Staff Report

To: Salt Lake City Planning Commission
From: Meagan Booth, Principal Planner
385-395-9035, meagan.booth@slcgov.com
Date: October 15, 2021
Re: DeWitt Design Review@ 352 S 500 E - PLNPCM2021-00649

DESIGN REVIEW

PROPERTY ADDRESS: 352 South 500 East
PARCEL ID: 16-06-403-027
MASTER PLAN: Central City
ZONING DISTRICT: R-MU (Residential Mixed-Use)

A1 EXTERIOR ELEVATION - EAST
1/8" = 1'-0"

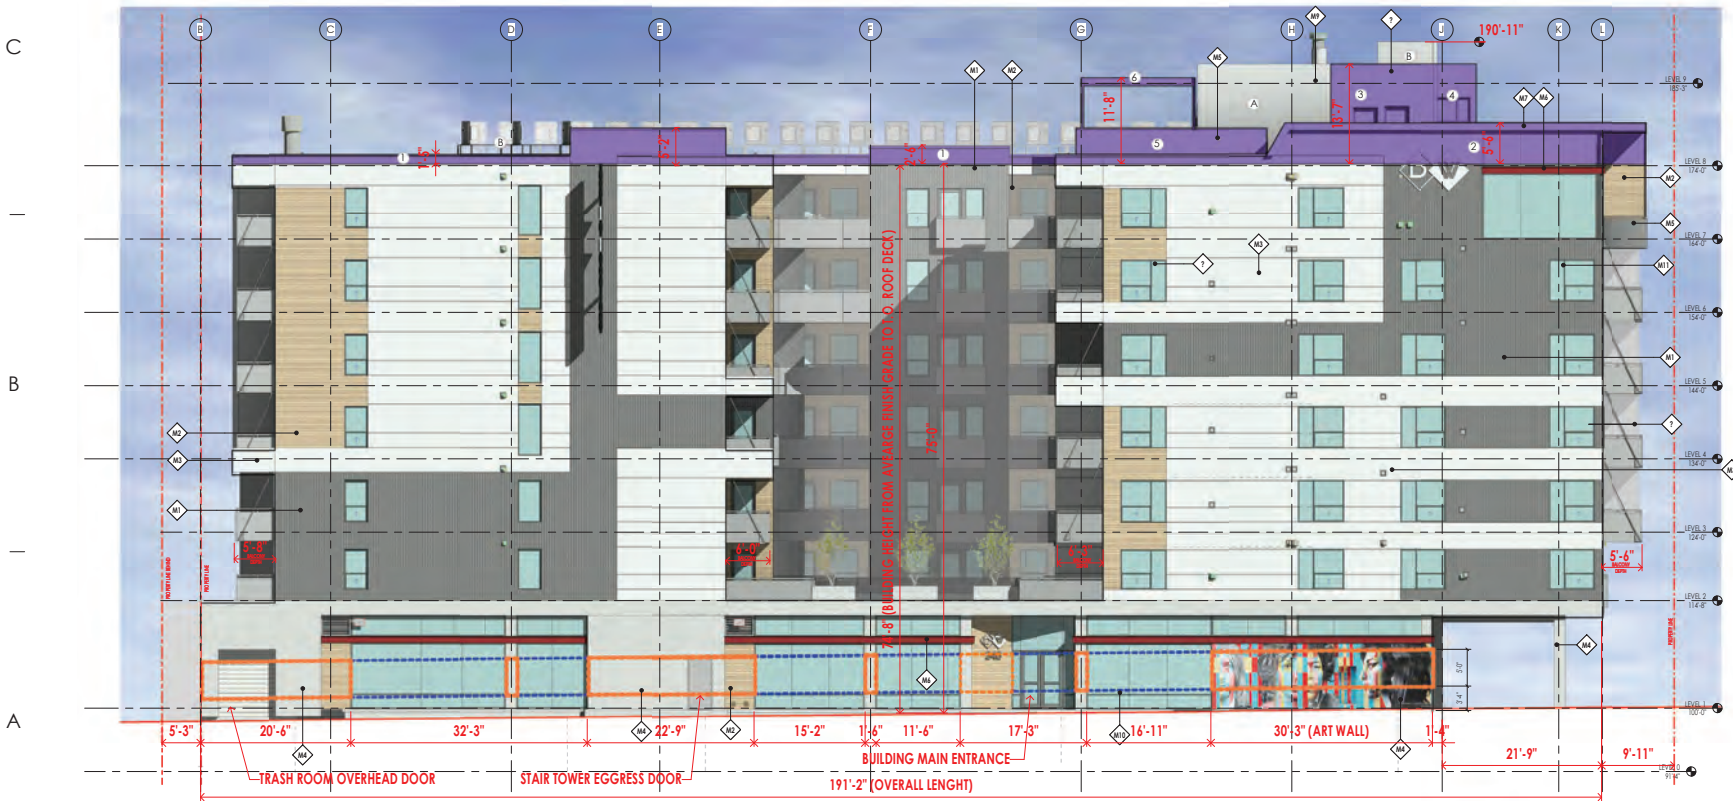
The street-facing glass area on level 1 has been increased to 49% to make lobby space more transparent and visually reduce the appearance of the cantilevered portion of the building. The RMU Zone requires Glass: ground floor (40%)

1 ROOF PLAN-DR
 1/8" = 1'-0"

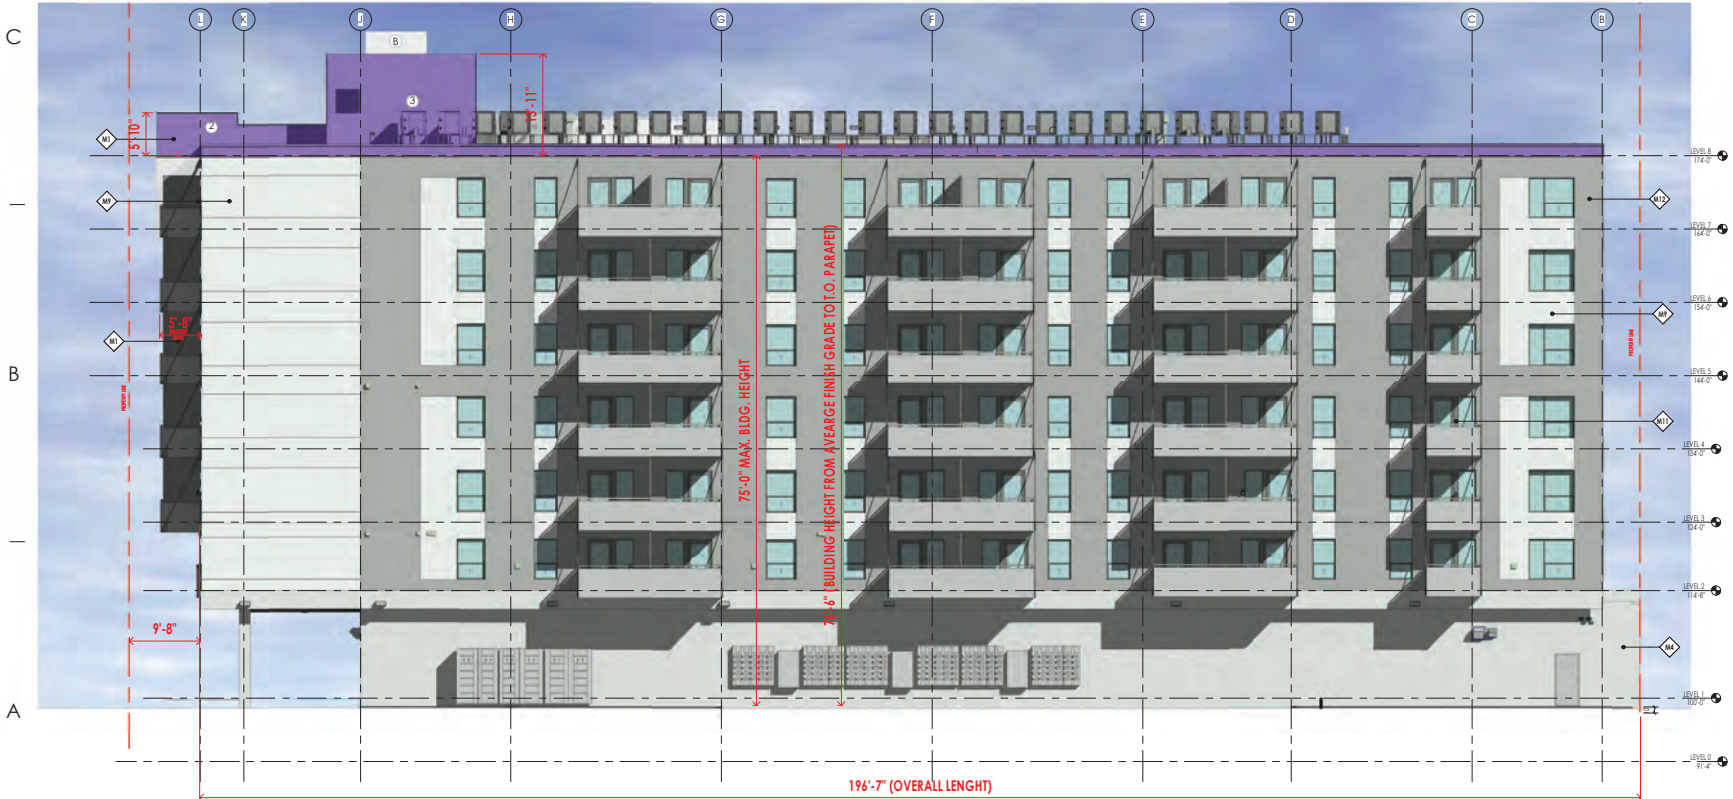
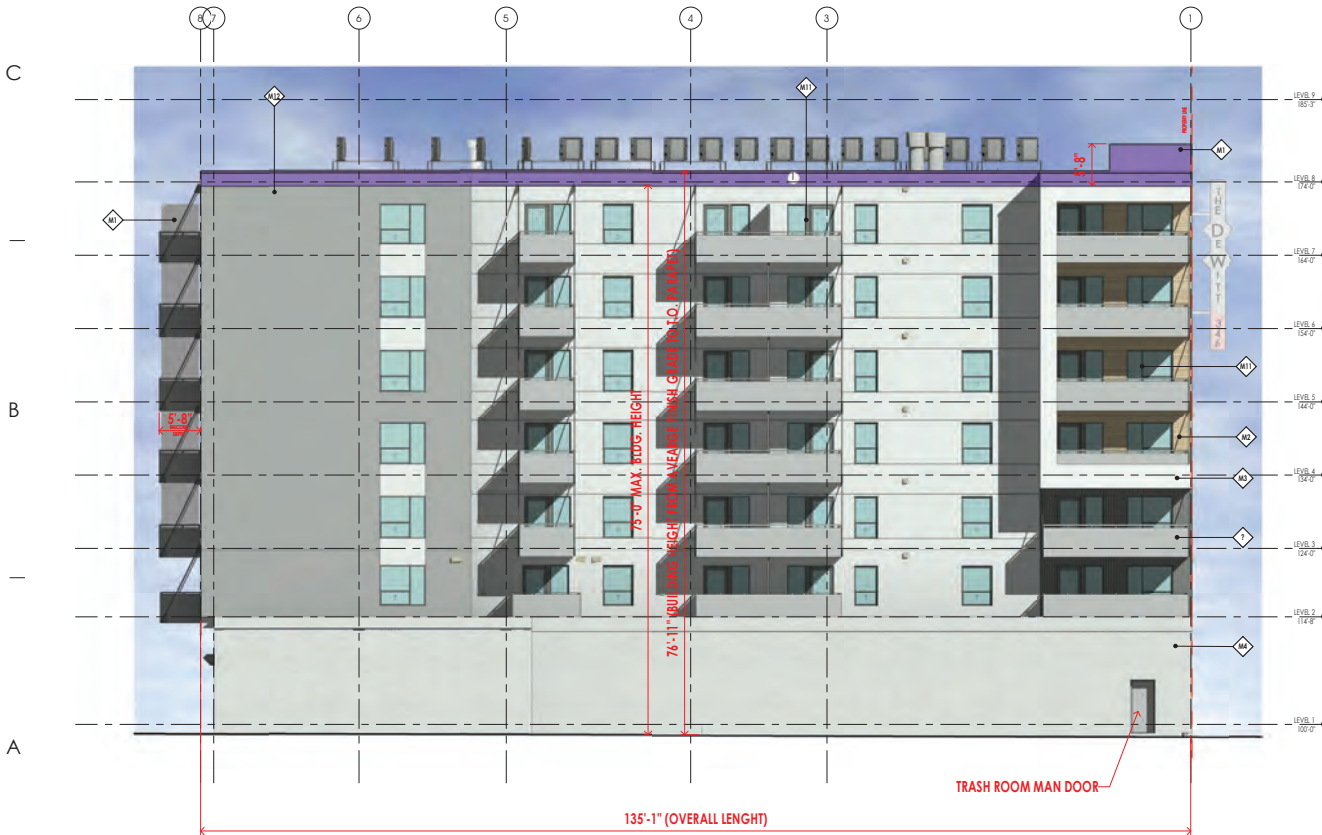
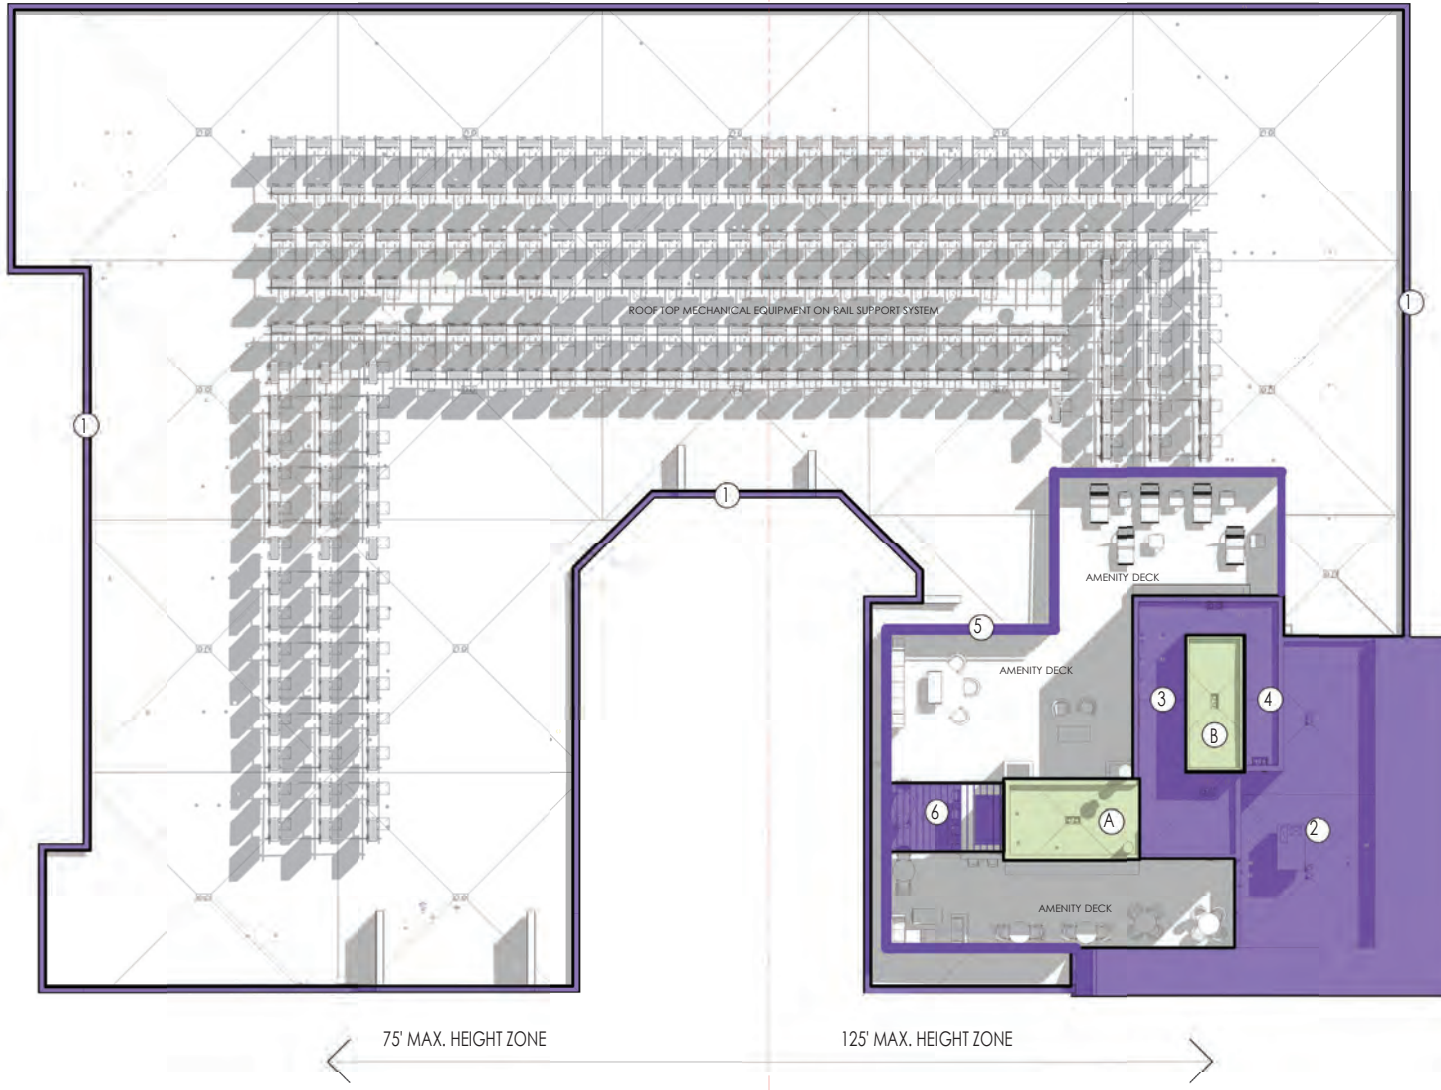
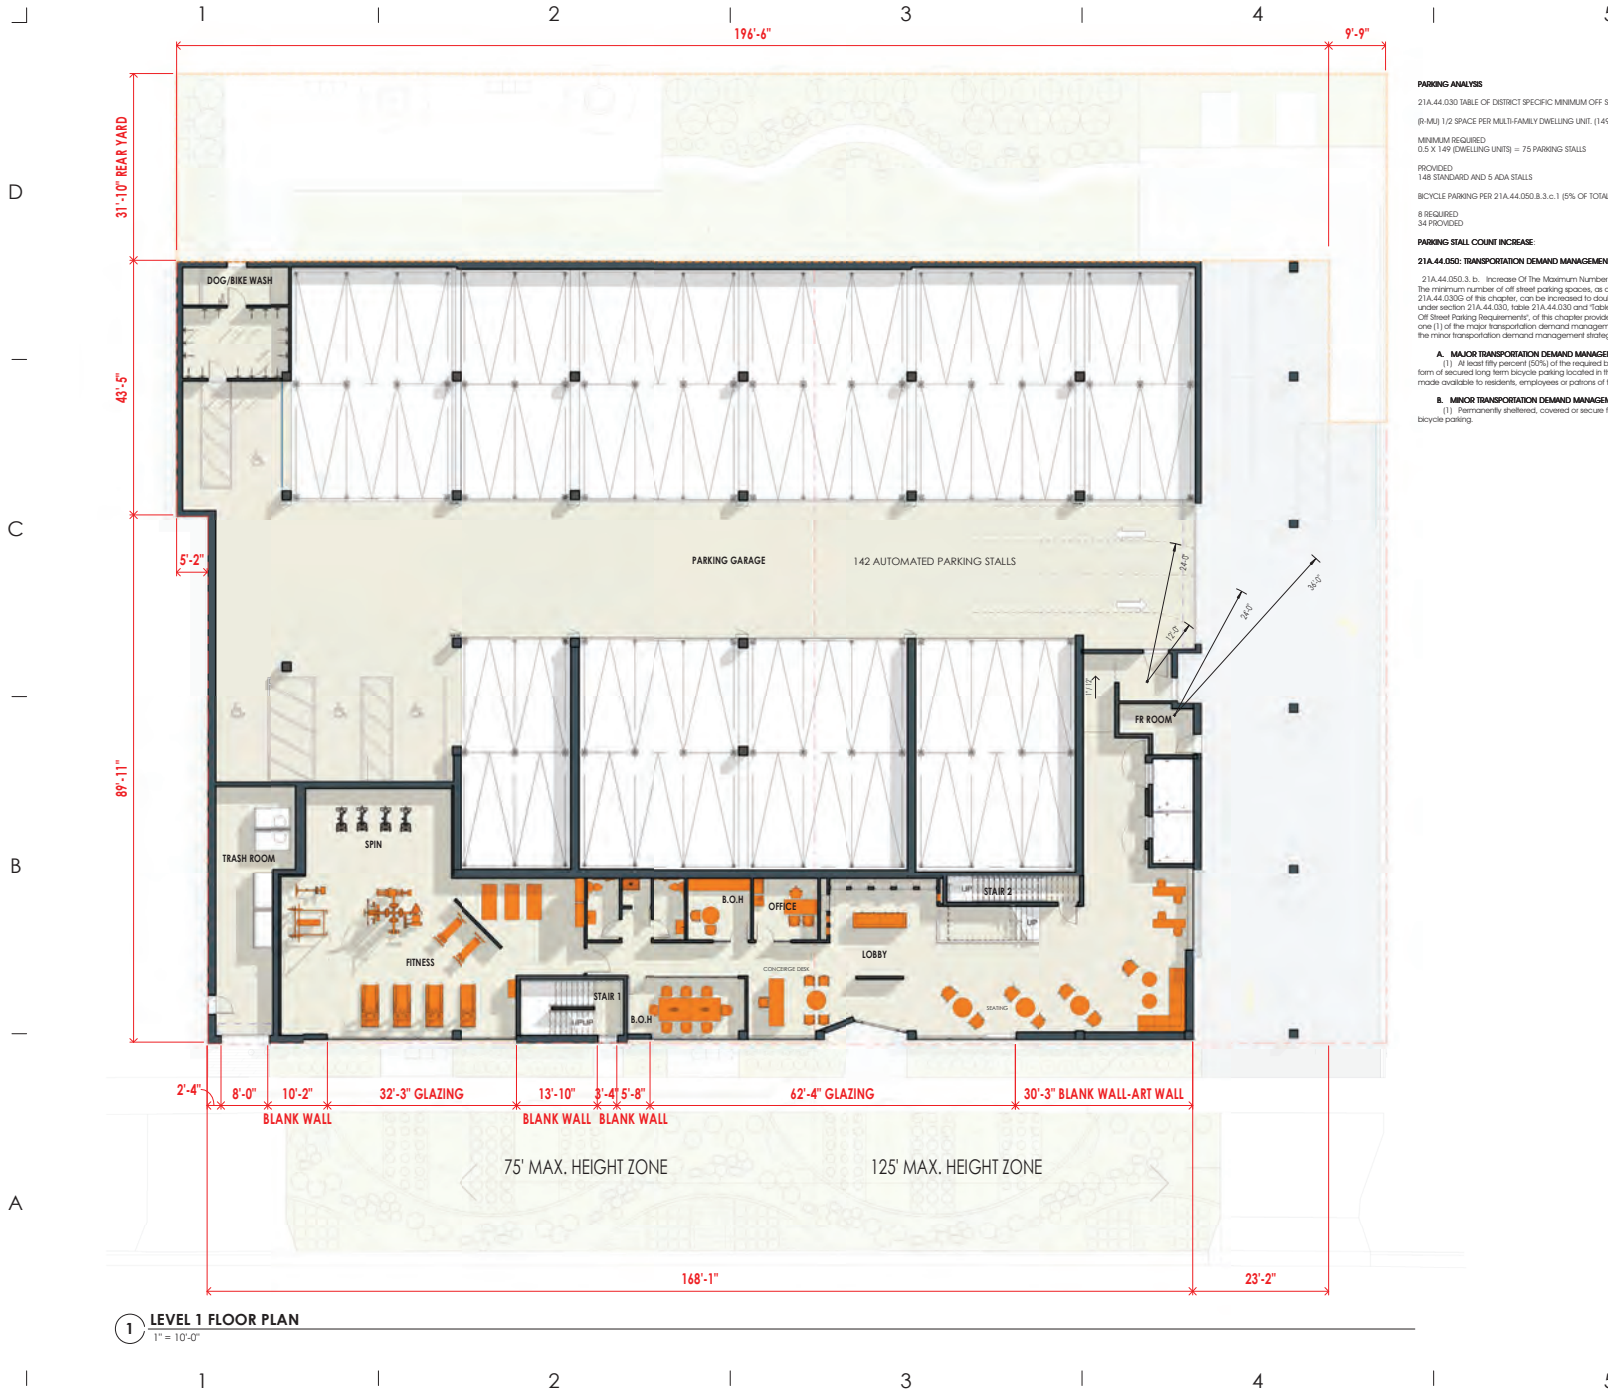
To show areas that exceed the 75-foot height restriction, the applicant submitted specific elevation sheets with purple shading. The club room and amenity space are positioned on the 86-foot-tall structure's north east most corner. The pergola and the elevator shaft to the rooftop deck were located at the highest points. On the elevation sheets, the applicant also indicated where the 125-foot zone landed on the building's façade. (This area is indicated by the purple shading on the elevation sheets and narrative attached.)

SHEET NAME:
LEVEL 1 FLOOR PLAN

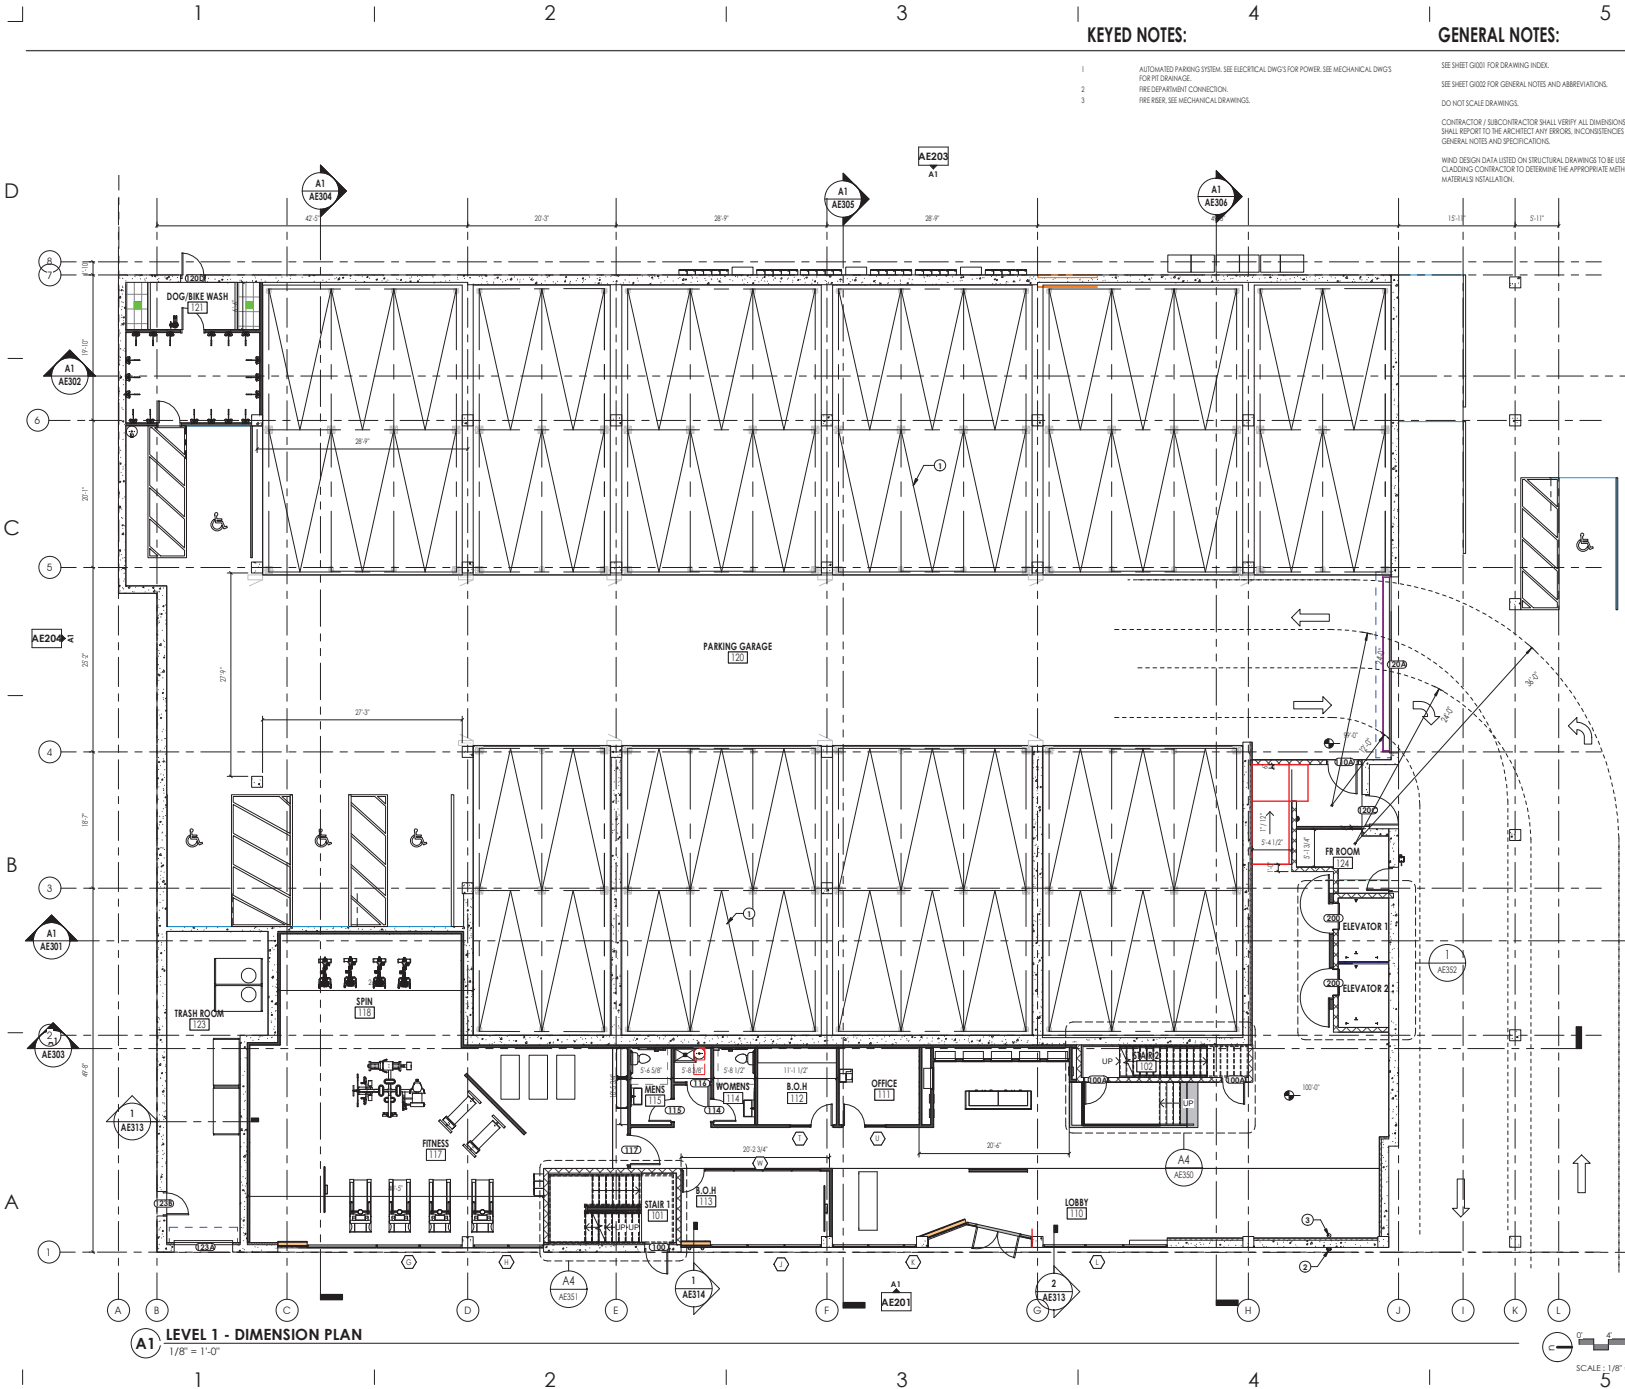
3. Bike parking: The thing that gets me hung up on this one is that the ordinance states that the location of the bicycle parking shall include a pathway (or sidewalk) that is connected to the right-of-way and is clearly separated from the parking lot and drive lanes. In this case, the bikers would be riding down the driveway, through the parking area and into the bike room, which doesn't meet the intent of the ordinance. I like the fact that they are providing a room for bike storage and especially because some of these units are small and space is at a premium. would suggest that they install four (4) bike racks (8 bike spaces) in the front of the building meeting all the specific bike rack location standards; this would satisfy their bike parking requirement. They can keep the storage room with bike racks, but maybe just call it "storage".

ajc response: We suggest adding a 4'-0" door from the public alley on the south property line to access the indoor bike storage. Updated Level 1 floor plan and site plan attached.

Grading at the public alley does not work with the Level 1 indoor bicycle storage finished floor grading. The access door cannot be provided. Hence in addition to bicycle storage at Level 1, we propose to add secured storage at the basement level with 6 additional parking stalls (4 stalls are required – 50%). The basement bicycle storage will be accessible from the public right-of-way through the building lobby and elevator.
